ADDENDUM NO. 2

ITB No. 08-0202

Data Center Fire Suppression Upgrade for County Administration Building

Item 1: Note the following changes to the plans as a result of the Pre-Bid Meeting. Changes noted on pages two (2) through (5) respectively.

M3.01R3

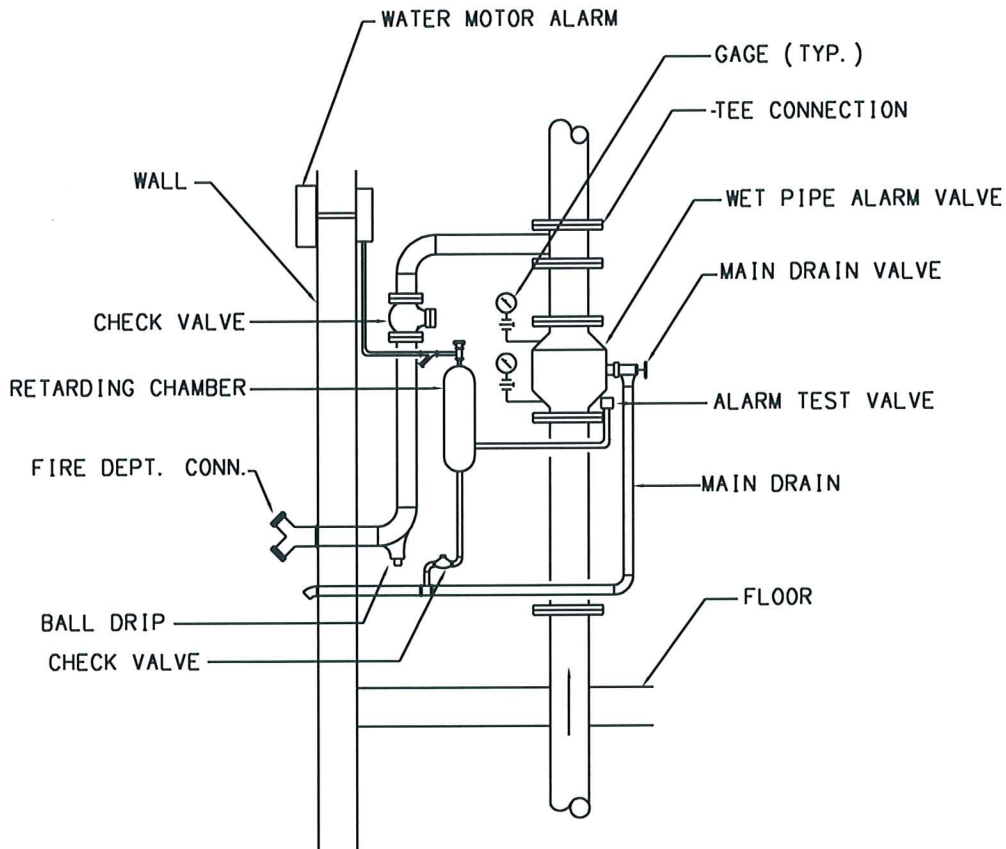
- ① NOZZLE BELOW RAISED FLOOR
- ② PROVIDE AUTOMATIC DAMPERS THROUGH ALL EXISTING WALL PENETRATIONS. VERIFY DUCT SIZES IN FIELD. DAMPERS SHALL BE CLOSED WHEN FIRE SUPPRESSION SYSTEM IS DISCHARGING.
- ③ EXISTING LIEBERT AHU TO REMAIN.
- ④ FIKE CLEAN AGENT STORAGE CONTAINER MODEL 70-156, 24" DIA 48" TALL, 350LB EMPTY.
- ⑤ COORDINATE NOZZLE LOCATION WITH EXISTING SWITCH RACK LOCATIONS.
- ⑥ EXISTING SPRINKLER HEADS ARE TO REMAIN IN PLACE.
- ⑦ EXISTING AHU TO REMAIN.

8. THE CONTRACTOR SHALL INCLUDE IN HIS BID ALL COSTS RELATED TO REMOVING AND REPLACING ALL CEILINGS AS REQUIRED FOR THE MECHANICAL AND ELECTRICAL WORK ON THIS PROJECT. CEILING TILES ARE TO BE NON-POROUS VINYL COVERED OR EQUIVALENT. CEILING TILES ARE TO BE CLIPPED DOWN FOR BETTER GAS CONTAINMENT.

11. FIRE SUPPRESSION CONTROL PANEL SHALL BE CONNECTED TO THE NEAREST 20A CIRCUIT.
12. FIRE SUPPRESSION CONTRACTOR IS RESPONSIBLE FOR SUPPLYING ALL AUTOMATIC DAMPERS. DAMPER POWER IS TO BE PROVIDED BY LAKE COUNTY FACILITIES PRIOR TO CONSTRUCTION.

13. FOR BETTER AGENT RETAINAGE EXISTING HOLES IN THE CORRIDOR WALL ARE TO BE PATCHED BY LAKE COUNTY FACILITIES PRIOR TO CONSTRUCTION. EXISTING VENTED LIGHT FIXTURES ARE TO BE REPLACED WITH UNVENTED FIXTURES BY LAKE COUNTY FACILITIES PRIOR TO CONSTRUCTION.
